M5 Junction 10 Improvements Scheme

Change Applications Consultation Document TR010063 - APP 10.14

Nationally Significant Infrastructure Projects: Changes to an application after it has
been accepted for examination

Volume 10
October 2024

Figure 3-3 Link Road cross-section with proposed changes

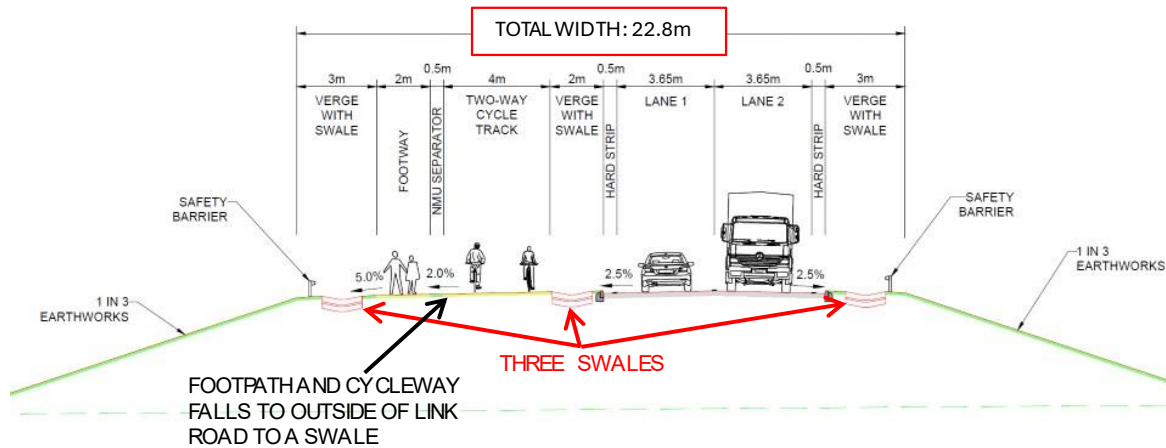
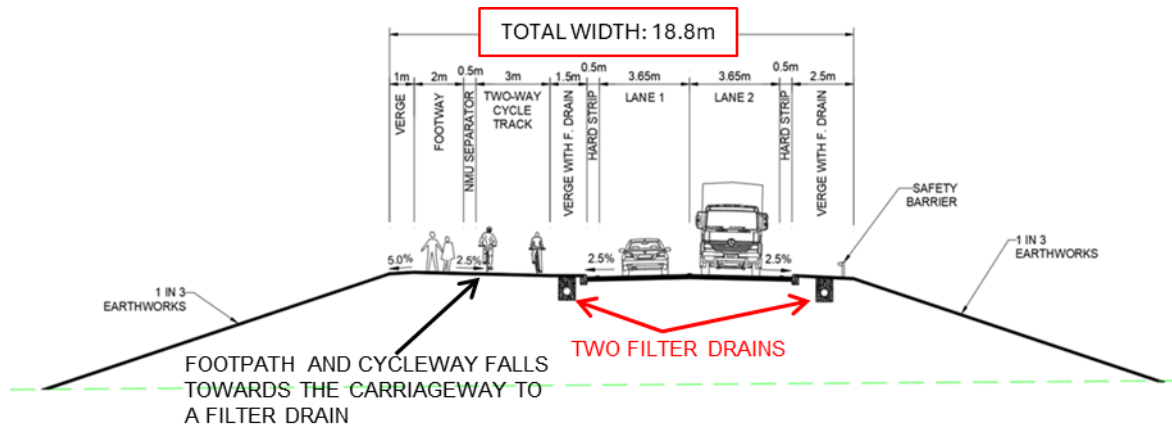
- 3.2.1. The Scheme currently proposes three runs of swales as the surface water collection method on the Link Road [see Figure 3-2].
- 3.2.2. The Applicant proposes to replace the swales with filter drains. Filter drains provide the following improvements:

- Are narrower than swales, which would allow the width of the Link Road to be reduced. This would decrease the quantity of fill material to be imported, and the footprint of the Link Road in the flood plain.

- Can connect to bridge deck drainage solutions for the River Chelt bridge, and the flood alleviation bridges.
- 3.2.3. Furthermore, altering the cross-section of the Link Road means that the number of filter drain runs can be reduced from three to two [see Figure 3-3].

- 3.2.4. In combination with the optimisation of the two-way footway cycleway in Change 4, these changes result in a 4m reduction in the width of the Link Road.

- 3.5.3. In addition, the Applicant proposes to reduce the width of the two-way footway cycleway from 4m to 3m to optimise the width of the Link Road [see Figures 3-2 and 3-3]. A review of the potential number of future cyclists identified that a 3m wide cycleway would be more than sufficient for the number of users identified.

Figure 3-5 Elevation of the flood alleviation bridge

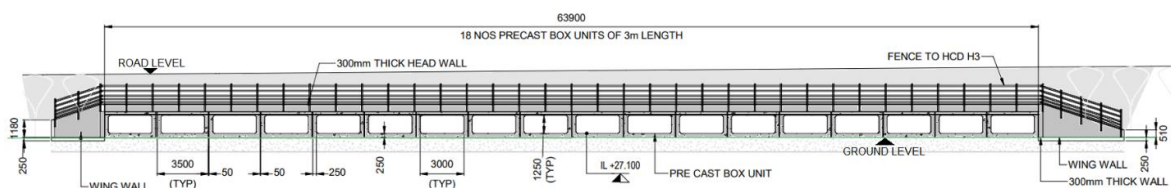
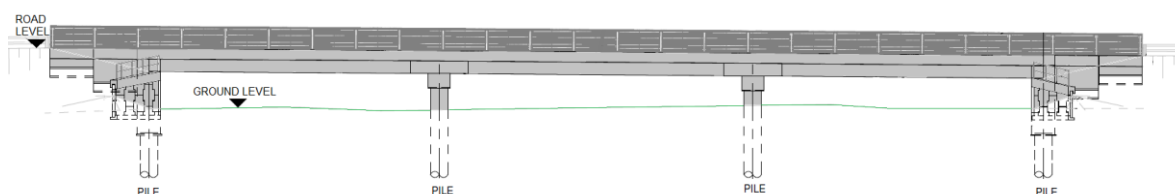
- 3.3.1. The Scheme design proposes two flood alleviation structures on the Link Road, to allow flood water to pass under the Link Road [see Figure 3-4]. These structures were to be constructed from rectangular, precast concrete units, to create a series of culverts.
- 3.3.2. Through a buildability review, several key risks were identified for the proposed culverts:
- As the culverts would be constructed from individual units, there is a risk that the units could settle by variable amounts. This would affect the rideability of the road and could damage the road surface.

- Ground improvement works (dig and replace) would be required.
- The import and storage of the units will be logistically complicated and add risk to the duration of the construction programme.
- Some culverts are over 30m long, so may not be used by local wildlife.
- The internal dimensions of the units would create a confined space for maintenance.
- The ground improvements, material storage and placement of the units would all take place within the flood plain over a prolonged period. If flooding was to occur, the construction programme would be lengthened. Also, flood compensation would need to be created to manage flood risk during the works, which would add space constraints to construction activities.

3.3.3. The Applicant proposes to change the flood alleviation structures from culverts to bridges [see Figure 3-5]. These bridges would provide the following betterment:

- Mitigate the risk of settlement, thereby improving the rideability of the road and reducing the risk of damage to the road surface.
- Have piled foundations, so the ground improvements would no longer be required.
- Reduce the working time and space requirements within the floodplain.
- Remove the confined space hazard for inspection and maintenance.
- The bridges would have a larger opening than the culverts, which reduces the risk of blockages in a flood event, but also encourages the movement of wildlife.

Figure 3-8 Plan of proposed square River Chelt bridge with straighter River Chelt

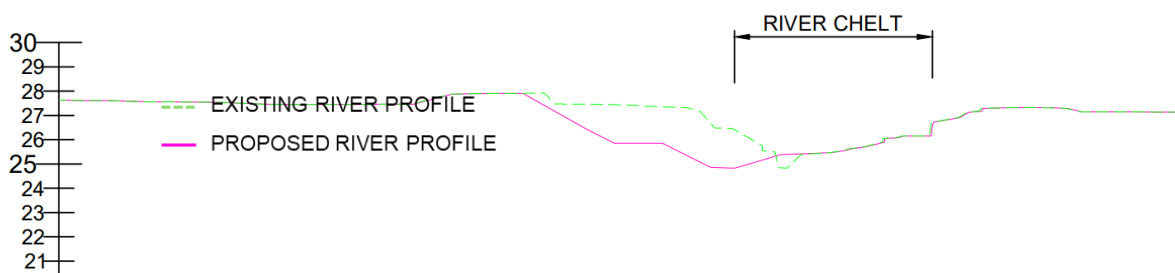
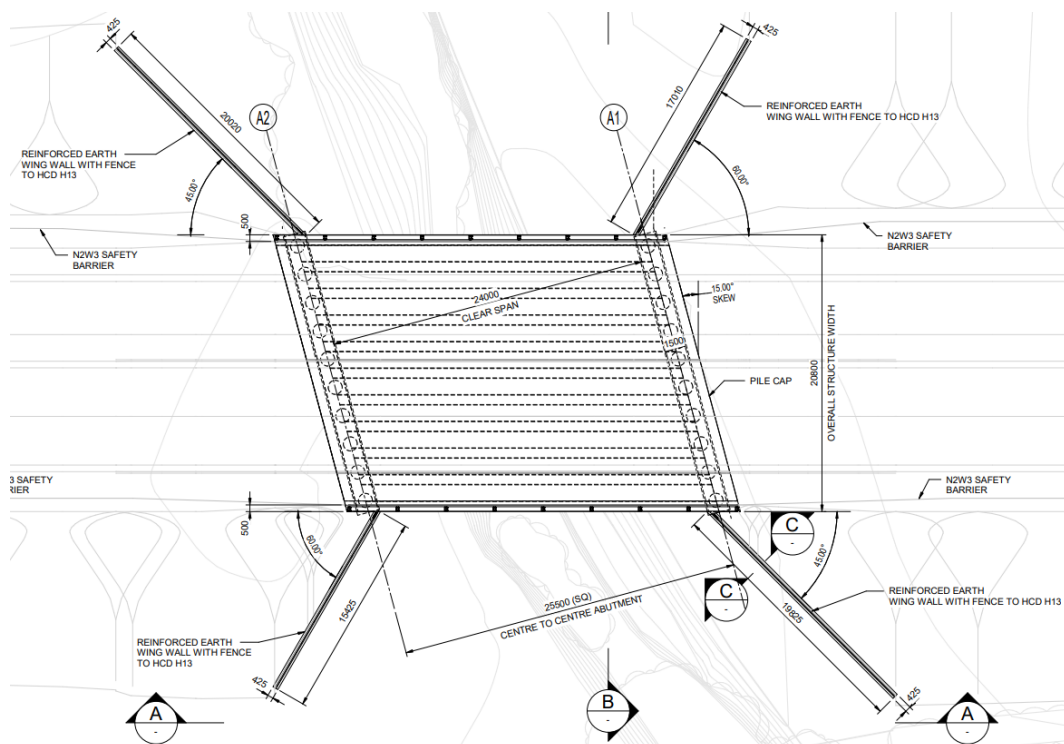
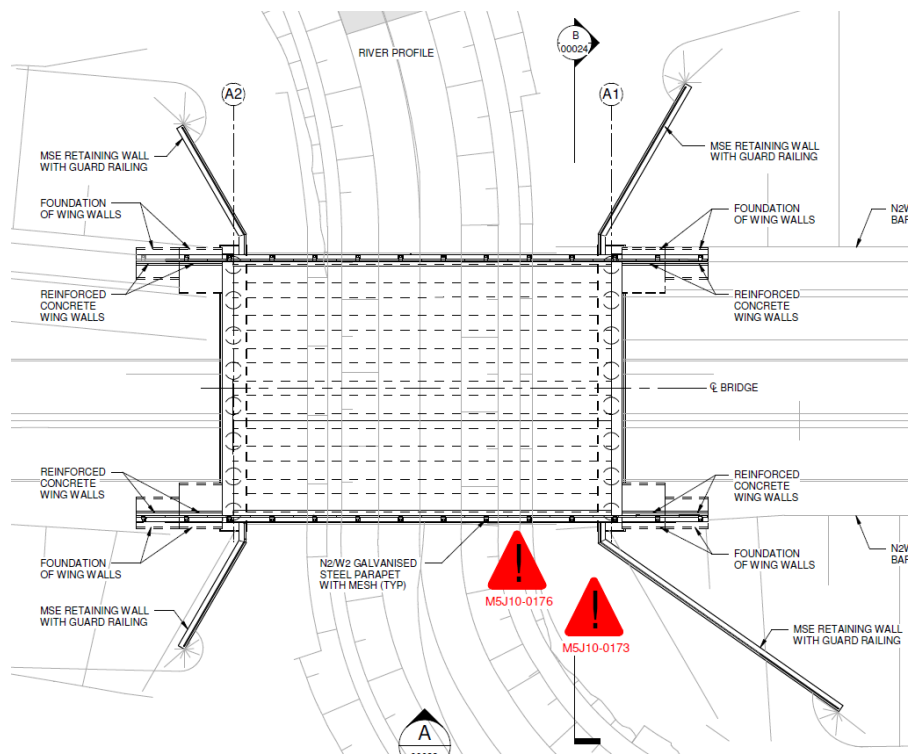
- 3.4.1. The bridge over the River Chelt proposed in the current Scheme is a skewed structure [see Figure 3-7], i.e. the bridge abutments are not perpendicular to the Link Road. The Scheme design also includes some reprofiling of the existing riverbank to reduce the risk of erosion and create more natural channel profiles [see Figure 3-6].
- 3.4.2. Skewed bridges are more difficult to design and construct and they introduce risk to the construction programme. Also, bridges with abutments that are perpendicular to the road generally perform better in the long-term, reducing the maintenance requirements.

- 3.4.3. The Applicant proposes to optimise the riverbank reprofiling works to straighten the River Chelt over a short length, so that it runs perpendicular to the Link Road [see Figure 3-8]. This would remove the skew in the bridge, mitigate risk to the construction programme, and improve long term structure performance.

- 3.4.4. To mitigate for the section of straightened channel, the River Chelt will be reprofiled to exaggerate the natural meandering downstream of the River Chelt bridge and include pools and riffles between meanders. The Scheme mitigation, including enhancements to riparian vegetation, bank reprofiling to create more natural profiles and installation of in channel enhancements, will also be further developed within the Order limits which are extended 160m upstream and 100m downstream of the River Chelt Link Road bridge.

- 3.4.5. The bridge would have a shorter span, which means that smaller beams can be used. As a result, the height of the Link Road can be reduced, in turn reducing the requirement for imported fill material.

Figure 3-10 Link Road long-section showing Scheme design vs proposed change

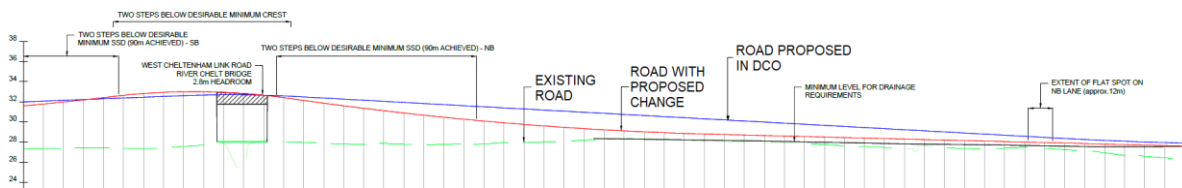
- 3.5.2. The Applicant proposes to optimise the vertical alignment of the Link Road beyond the LoD, by reducing the height of the road by over 1m in localised areas [see Figure 3-10]. This would result in significant reductions in the requirement for imported fill.

Figure 3-16 Location of existing and proposed TS

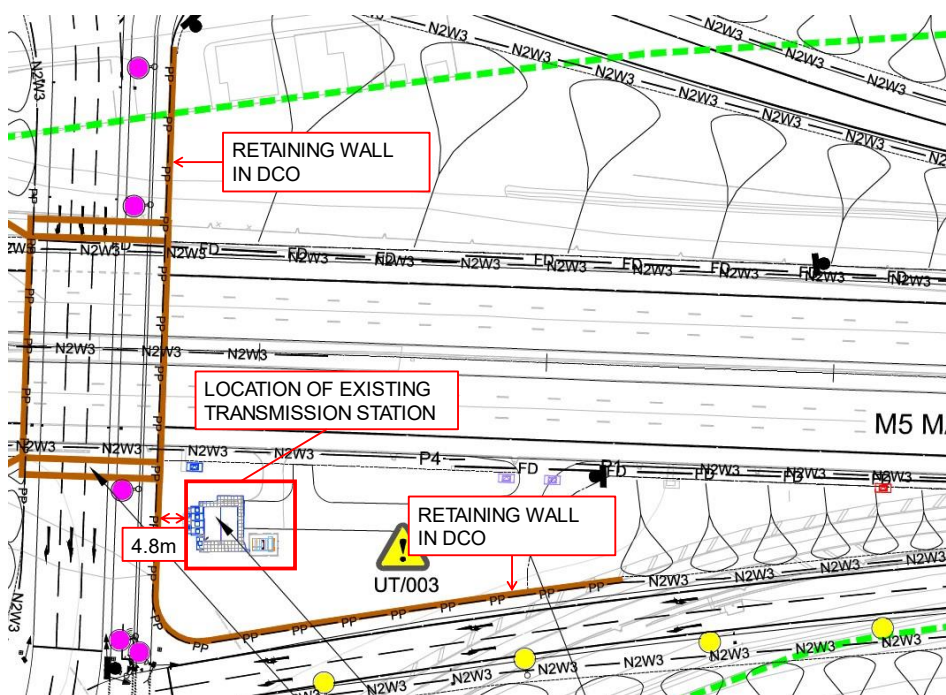
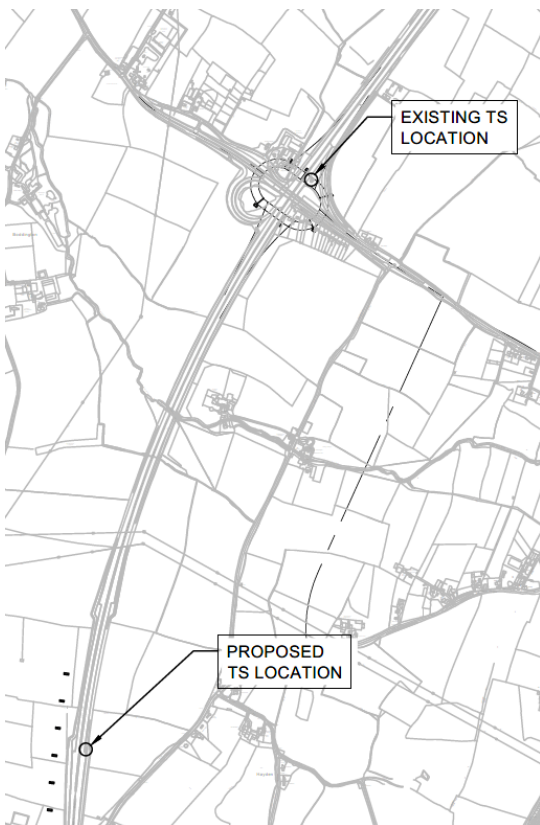
- 3.6.1. The location of the existing Uckington NRTS transmission station (TS) is in close proximity (4.9m) to the construction works proposed for the Piffs Elm bridge north [See Figures 3-11, 3-12 and 3-13]

- 3.6.2. The construction works required around the TS include reinforced earth retaining walls and sheet piling, which pose a health and safety risk to the construction operatives working in close proximity to the structure.

- 3.6.3. The works would also pose a risk to the TS structure and the power and communication cables which run to the TS. The National Telecommunication Roadside Service (NRTS) provides a data link around National Highways' roadside telecommunications network. This link must be kept in operation at all times. During construction, an interrupter bypass cable will be required to divert the data link around the construction area and keep the network operational. The bypass cable would need to return to the TS to maintain the data link and would therefore run through the works area where it may be at risk of damage.

- 3.6.4. For these reasons, it has been determined that the TS needs to be relocated from its current location.
- 3.6.5. The new TS would be modular, similar to that shown in Figure 3-16, with approximate dimensions of 6.7m (L) x 4.8m (W) x 3m (H). The new TS will be located within the Scheme Order limits and highway boundary, approximately 2.6km south of the existing location [see Figures 3-14 and 3-15]. There is existing hardstanding in the verge of the southbound carriageway which would provide a suitable location.

- 3.6.6. Once the TS is relocated, the retaining walls will no longer be required for the Piffs Elm North bridge. As a result, the retaining walls on the north side of the east and west abutments would be replaced with planted embankments.

Figure 3-18 Plan of alternative flood storage area

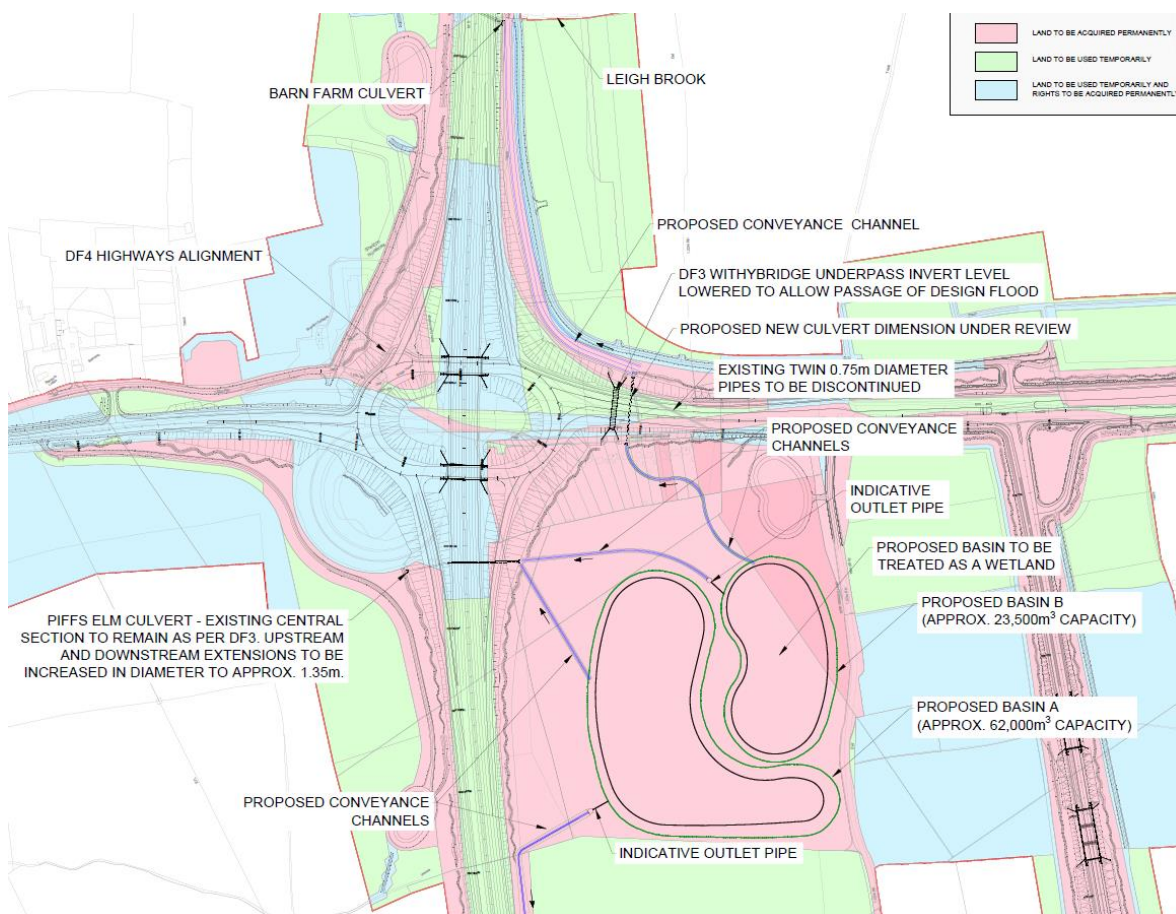
- 3.7.1. The current Scheme design proposes a flood storage area, to store around 200,000m³ of flood waters from the River Chelt. The storage is located to the south-east of the Piffs Elm Interchange, between the M5 Corridor, the A4019 and the Link Road [see Figure 3-17]. The solution was developed based on the following principles:

- The existing 750mm diameter pipes that pass under the A4019 were both proposed to be stopped up.
- 3.7.2. This flood storage area would need to be registered as a large-raised reservoir under the Reservoirs Act 1975. In the design flood event, the M5 and A4019 embankments would act as impoundment structures under the Reservoirs Act 1975. This means that the M5 and A4019 embankments form the dam to the reservoir. This would place significant responsibilities on the maintaining parties. National Highways have raised their concerns in relation to the Scheme proposals for the design, operation and maintenance of the current flood storage area, which has led the Applicant to explore alternative solutions.

- 3.7.3. The Applicant proposes an alternative flood storage solution which would allow flood waters to flow north of the A4019 and reduce the volume of water that would be stored to the south-east of the Piffs Elm Interchange [see Figure 3-18].

- 3.7.4. The alternative solution is as follows:
- Two separate basins to store 23,500m³ and 61,000m³ entirely below the current ground level.
 - Creation of channels to carry floodwater from the basins to the River Chelt, to the existing Piffs Elm culvert underneath the M5, and through the Withybridge underpass.

- New culverts will be created under the A4019, with a new ditch to carry flows to Leigh brook, which then passes under the M5 through the Barn Farm culvert. In order to create sufficient space for the new ditch to Leigh brook, the M5 southbound off-slip road has been shortened by 55m to 348m total length. Appendix F of the Transport Assessment [TR010063 - APP 7.5] shows that the maximum queue length on the southbound off-slip (M5 North approach SB) in the 2042 scenario is 56 PCU in the am peak. This is equivalent to 336m and therefore within the new slip road length.

- Withybridge underpass lowered and existing 750mm pipes under A4019 replaced with twin culverts, to provide flood conveyance under the A4019.
- 3.7.5. This solution would not use either the M5 or the A4019 road embankments as impoundment structures for the reservoir. As a result, the solution minimises the maintenance responsibilities required under the Reservoirs Act 1975.

Figure 3-19 Location of the infill of the northbound on-slip loop

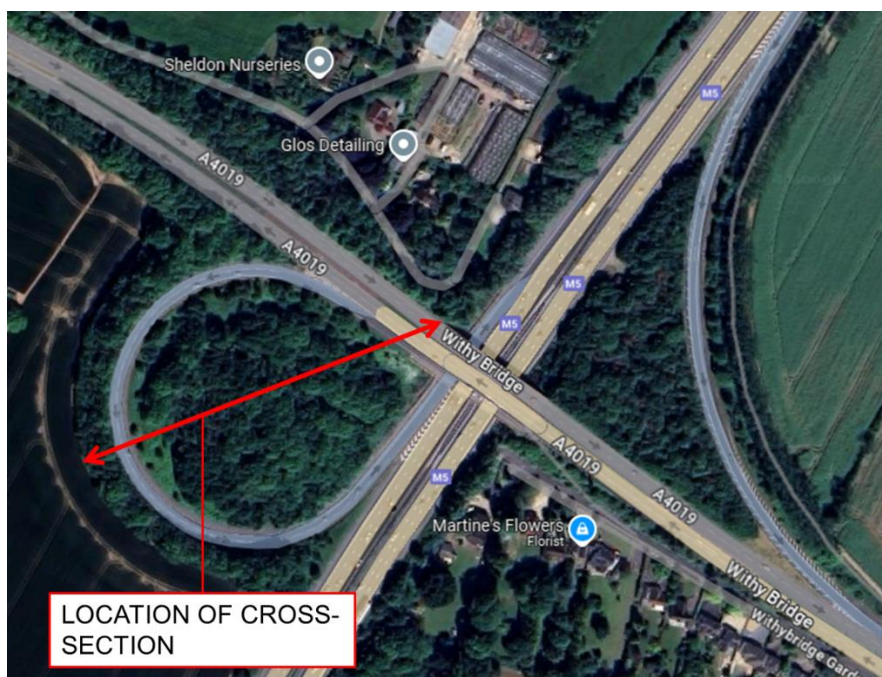
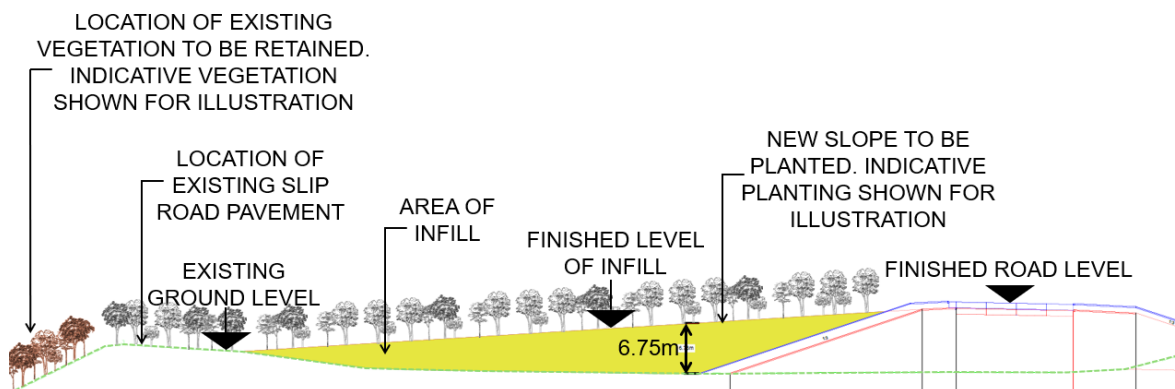
- 3.8.1. The existing M5 J10 northbound on-slip loops onto the M5 carriageway. The current Scheme design proposes to retain the embankment loop in its current form.
- 3.8.2. The Applicant proposes to infill the loop with site won material [see Figures 3-19 and 3-20], which is not suitable to be reused elsewhere, in order to create a new slope for planting and provide improved screening of the Piiffs Elm Interchange.
- 3.8.3. This proposal would reduce the export of unsuitable material, thereby reducing the number of construction vehicle movements and the Scheme greenhouse gas emissions.
- 3.8.4. This change would ease the maintenance of the proposed planting as the gradient of the south-west embankment of the Piiffs Elm Interchange would be significantly reduced.
- 3.8.5. The environmental effects of this change are outlined below:
